**PLANNING APPROVAL,
PLANNED UNIT DEVELOPMENT &
SUBDIVISION STAFF REPORT****Date: November 20, 2008**

<u>NAME</u>	Apostolic Pentecostal Holy Church of God Subdivision
<u>SUBDIVISION NAME</u>	Apostolic Pentecostal Holy Church of God Subdivision
<u>LOCATION</u>	1710 Bolden Street and 1711 Williams Street (East side of Bolden Street, 200'± North of Carter Avenue, extending to the West side of William Street, 100'± North of Carter Avenue)
<u>CITY COUNCIL DISTRICT</u>	District 1
<u>PRESENT ZONING</u>	R-1, Single-Family Residence District
<u>AREA OF PROPERTY</u>	2 lots / 0.73 acres ±
<u>CONTEMPLATED USE</u>	Planning Approval to allow the construction of a new parking lot at an existing church in an R-1, Single-Family Residential district; Planned Unit Development approval to allow two buildings on a single building site; and Subdivision approval to create two legal lots of record.
<u>TIME SCHEDULE FOR DEVELOPMENT</u>	Immediate

SUBDIVISION DETAIL

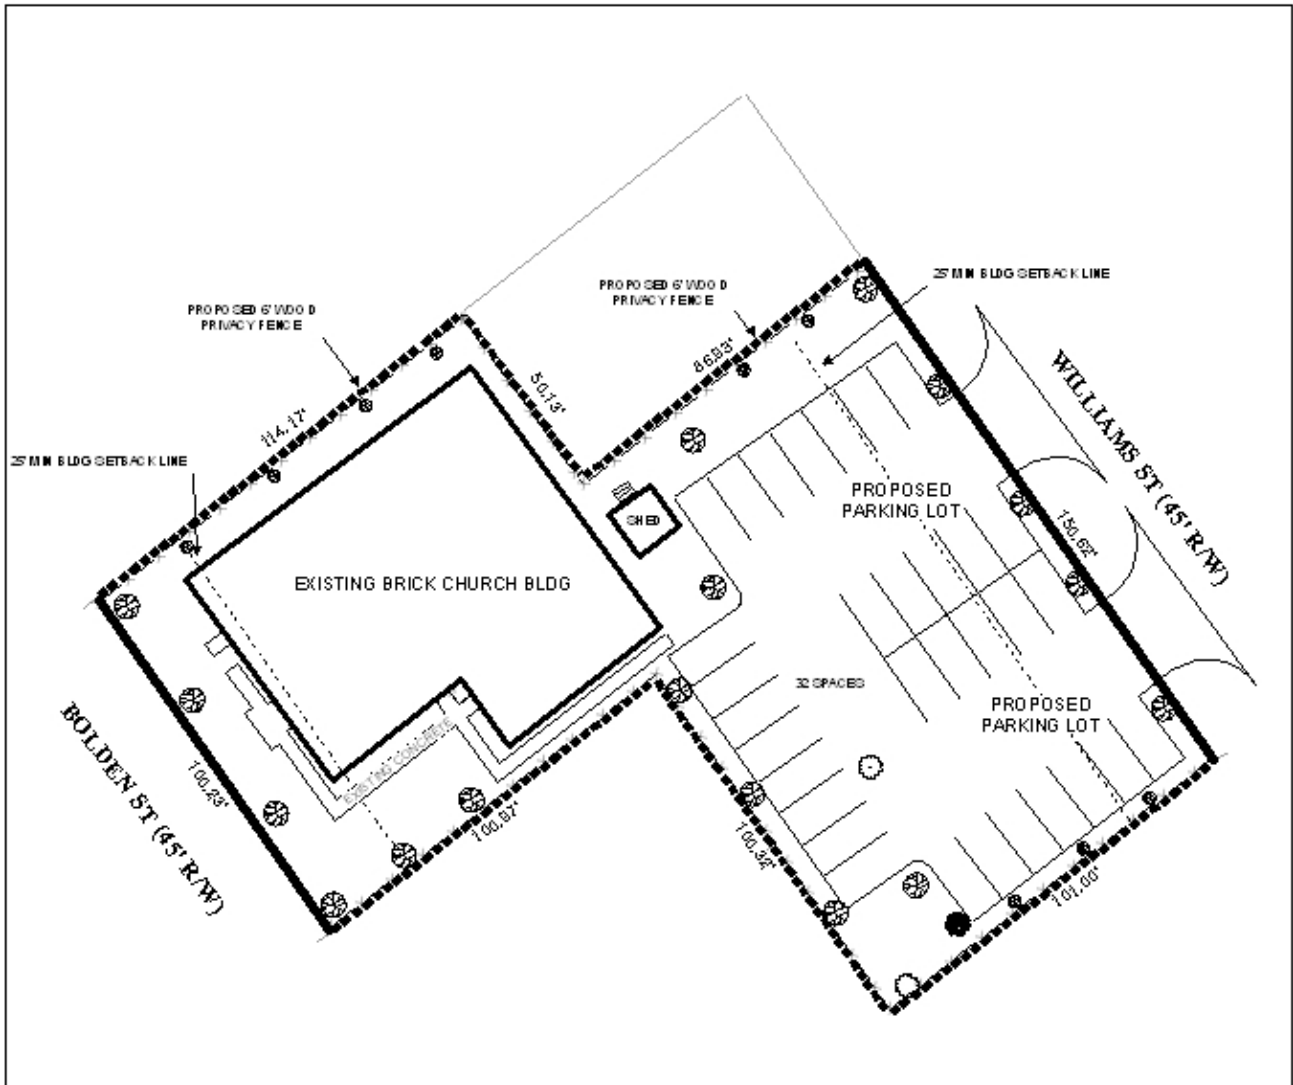
Neither Bolden Street nor William Street are provided with curb and gutter; and both streets have an inadequate right-of-way of 45 feet. The Subdivision Regulations specify that minor streets not provided with curb and gutter require a right-of-way of 60 feet. A right-of-way dedication would seem to be uncharacteristic of the surrounding neighborhood. As such, the plat should be revised to depict a 35 foot setback along all right of way frontages to account for future right-of-way acquisition and street improvements, should such be deemed necessary in the future. Also of note, the plat and PUD/Planning Approval applications show William Street as Williams Street. City engineering records show that the correct street name is William Street, and, therefore, the plat should be revised to reflect this.

As mentioned earlier, one of the objectives of the subdivision application is to correct the encroachment of the existing church building. To that end, the lot line between the church building and an existing single family residence has been shifted northeasterly to accommodate the encroachment. The lot line shift will create another issue, namely, a rear yard setback issue for the church building and a rear yard setback issue for the existing single-family residence. In an R-1 Zoning District, a rear yard of eight feet is required. The lot line shift will create a rear yard of 6.2 feet for both structures. If the subdivision is approved, it should be under the condition that a rear yard setback variance be granted by the Board of Zoning Adjustments for both the church and the single family residence.

Additionally, the subdivision application, if approved, would further subdivide and already nonconforming 5316 square foot lot with 50.21 feet of public right-of-way frontage into a 4379 square foot lot with 50.21 feet of public right-of-way frontage. The Subdivision Regulations require a minimum lot size of at least 7200 square feet for a lot served by public water and sanitary sewer and public right-of-way frontage of at least 60 feet. Therefore a waiver of section V.D.2 of the Subdivision Regulations may be appropriate.

- 1) Revision of the plat to remove depiction of the insufficient dedication and instead depict a 35 foot setback line from the existing right-of-way;
- 2) Provision of a note on the plat limiting Lot 1 to one curb cut onto Bolden Street and two curb cuts onto William Street; and limiting Lot 2 to one curb cut onto William Street;
- 3) Revision of the plat to reflect to correct name of William Street;
- 4) Submission of a rear yard setback variance application for the existing church building on the proposed Lot 1; and
- 5) Submission of a rear yard setback variance application for the existing single-family residence on the proposed Lot 2.

SITE PLAN

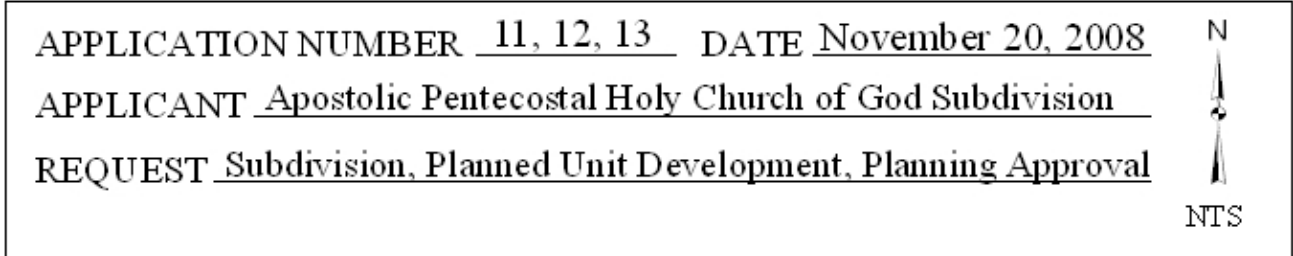
Driveway number, size, location, and design to be approved by Traffic Engineering and conform to AASHTO standards. Final approval for all driveways, proposed and existing will be given upon submittal of final plans. The two

driveways shown on the plan are located less than ten feet apart. The new parking area should be limited to one two-way driveway cut or two one-way driveway cuts.

The Planned Unit Development is required because there are multiple buildings on a single building site. The additional building is a 157 square foot storage building not used for any purpose other than storage for the church. The site plan illustrates compliance with landscaping and tree planting requirements. The site plan further illustrates two, two-way curb cuts for the new parking area, the radii of each being within 10 feet of each other. Traffic engineering has commented the either the parking lot be redesigned to have only one two-way curb cut or to have two, one-way curb cuts of reduced width. As a result, the applicant should revise the submitted site plan for the Planning Approval and the PUD to reflect the Traffic Engineering comments. Also, should the applicant choose to have two one-way curb cuts, the curb cuts should be separated further by relocating them. This could be accomplished by adding a 10 foot planting strip between the two center aisles of parking. Further, no sidewalk is illustrated on the site plan, which is required for new construction. As no sidewalk waiver was applied form, it can only be assumed that the applicant intends to construct a city-standard sidewalk. As such, the site plan should be revised to illustrate the sidewalk.

The site plan illustrates a 6-foot high privacy fence between the church property and the surrounding properties being utilized for residential purposes. The fence should be retained on the site plan, but revised to show compliance with Section 64-4.D.6 of the Zoning Ordinance concerning height of fences in front yards.

It should be noted that the application states that the church building has a seating capacity of 200. According to the parking ratio of 1 space per 4 seats as prescribed in the Zoning Ordinance, 50 parking spaces would be needed. As the proposed parking area only includes 32 parking spaces, if the PUD is approved, it should be subject to the approval of a parking ratio variance from the Board of Zoning Adjustments. Additionally, no curbs or wheel stops are shown on the site plan for the parking stalls; the site plan should be revised to illustrate these for all parking stalls.

The applicant has stated that there will be no dumpster on site as the church does not currently use one and has no plans to add one. As such, the site plan should have a note placed on it detailing how garbage will be collected from the site.

The new construction for parking and the storage shed may result in a need for storm water detention. If a storm water detention pond is provided, the PUD and Planning Approval site plans should be revised to depict required detention.

The site has frontage onto two minor streets, Bolden Street and William Street. The site plan depicts the existing church building facing Bolden Street with no curb cuts onto Bolden Street, and the area between the building face and the street being landscaped. The site plan further depicts an existing shed to the rear of the church building, as well as a new 32-space parking lot with two curb cuts to William Street. Due to limited frontage onto William Street, Traffic Engineering has stated in their comments that the site should be limited to either one two-way curb cut onto William Street or two one-way curb cuts onto William Street. Also, due to the limited frontage, the site should be limited to one curb cut onto Bolden Street.

- 1) Revision of the site plan to reflect Traffic comments reference to number and location of curb cuts, including marking of one-way access ways, if applicable;
- 2) Revision of the site plan to depict either wheel stops or curbs at parking areas;
- 3) Revision of the site plan to depict sidewalks;
- 4) Revision of the site plan to depict dumpster location or provision of a note on the site plan addressing trash collection method;

- 5) Submittal of a variance application for the rear yard setback of the existing church building and a parking ratio variance;
- 6) Compliance with Engineering comments (*If the cumulative impervious area constructed since 1984 is equal to or greater than 4000 square feet, storm water detention is required. It is the responsibility of the applicant to look up the site in the City of Mobile (COM) GIS system and verify if NWI wetlands are depicted on the site. If the COM GIS shows wetlands on the site, it is the responsibility of the applicant to confirm or deny the existence of wetlands on-site. If wetlands are present, they should be depicted on plans and/or plat, and no work/disturbance can be performed without a permit from the Corps of Engineers. Must comply with all storm water and flood control ordinances. Any work performed in the right of way will require a right of way permit.*);

- 7) Revision of the site plan to depict and provision of a 6-foot high wooden privacy fence around the perimeter of the site where it abuts existing residential development, with the exception of within 35-feet of a street right-of-way, where the fence shall not exceed 3-feet in height;

- 8) Revision of the site plan to depict a storm water detention basin, if required by compliance with the City of Mobile storm water and flood control ordinances; and

- 9) Revision of the site plan to depict the 35-foot minimum building setback line.
